Tennessee Valley Authority, 1101 Market Street, Chattanooga, Tennessee 37402-2801

Browns Ferry Nuclear Plant, Units 1, 2, and 3
Facility Operating License Nos. DPR-33, DPR-52, and DPR-68
NRC Docket Nos. 50-259, 50-260, and 50-296

Subject: **Response to Request for Additional Information for Regarding
Generic Letter 2008-01, "Managing Gas Accumulation in
Emergency Core Cooling, Decay Heat Removal, and Containment
Spray Systems" (TAC Nos. MD7799, MD7800, and MD7801)**

Response to Request for Additional Information Regarding NRC Generic Letter 2008-01

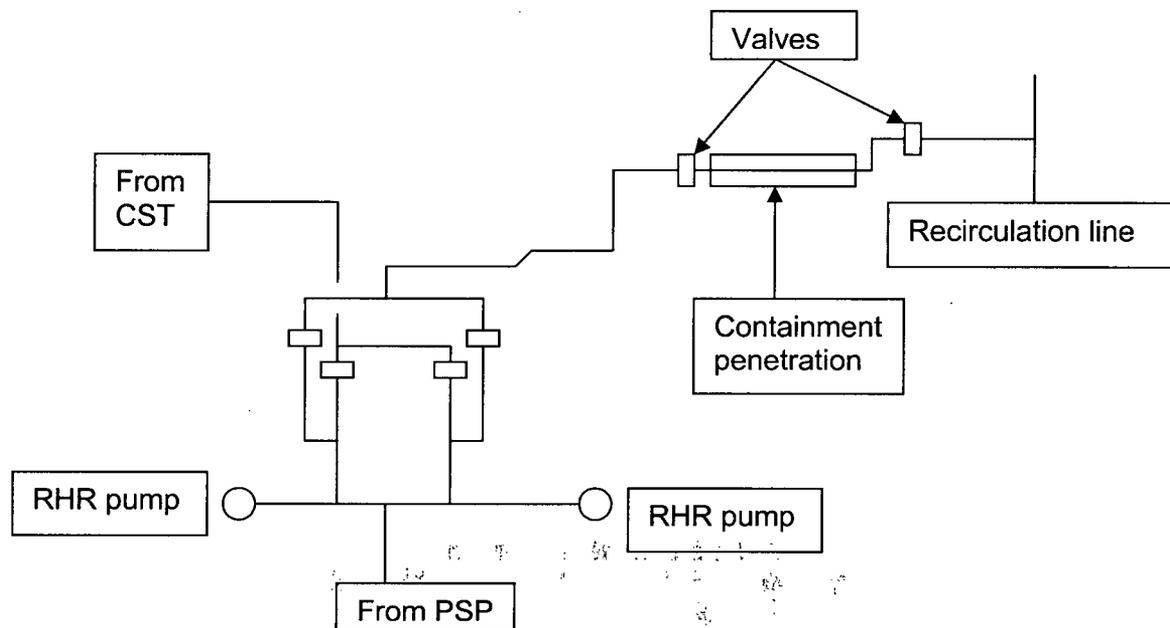
On page E1-4 of Enclosure 1 to the October 11, 2008 submittal, TVA indicated that a portion of the DHR system suction pipe from the primary system is located inside containment and, at the time of the July 11 2008 submittal, the survey of this pipe was deferred until the next refueling outage for each unit. Further, TVA stated that the configuration of this pipe and its distance from the DHR system pump suction would prevent it from containing a void large enough to cause a loss of the DHR system pumps when they take suction from the primary system. BFN also stated that the DHR system pumps have not become gas bound with their suctions aligned to the primary system for shutdown cooling and, therefore, this pipe is no longer required to be surveyed in upcoming refueling outages.

Provide the maximum void volume that could be held up in the DHR system pipes. Given the operating experience indicating that licensees are continuing to discover subject system voids that potentially jeopardize operability where a problem was not previously identified, how does historically not having pumps become gas bound justify a conclusion that there will not be a void problem?

The acceptability of voids in the horizontal RHR pump supply pipe from the RV located inside containment was not based on quantitative acceptance criteria (i.e., a maximum void volume). Rather, the GL 2008-01 evaluation based the acceptability of voids in this pipe on the suction pipe configuration. Specifically, there is < 18 feet of horizontal pipe inside the drywell and < 14 feet of horizontal pipe inside the containment penetration. These horizontal pipes are located > 45 feet above the pump suction with 5 horizontal to vertical pipe elbows in the suction flow path. Voids are trapped and split apart at these horizontal to vertical elbows and only small bubbles that do not affect pump operation travel towards the pump. In addition, > 11 feet above the RHR pump suction, the supply pipe from the RV connects to a vertical pipe through the branch of a horizontal to vertical

tee. Any voids in the flow stream from the RV supply to the RHR pump are stripped out of the flow stream at this location and remain trapped in a dead leg of the RHR pump supply from the CST. This pipe configuration is illustrated in the below figure, which is not to scale and has been rotated several times for clarity.

The 18 feet section of horizontal pipe in containment was surveyed during the Unit 1 and 2 refueling outages. The Unit 1 and 2 pipes were found to be level to within 0.2 inches resulting in a maximum potential latent void volume of < 0.1 cubic feet. As previously committed to in Reference 1, the Unit 3 pipe segment will be surveyed at the next Unit 3 refueling outage.
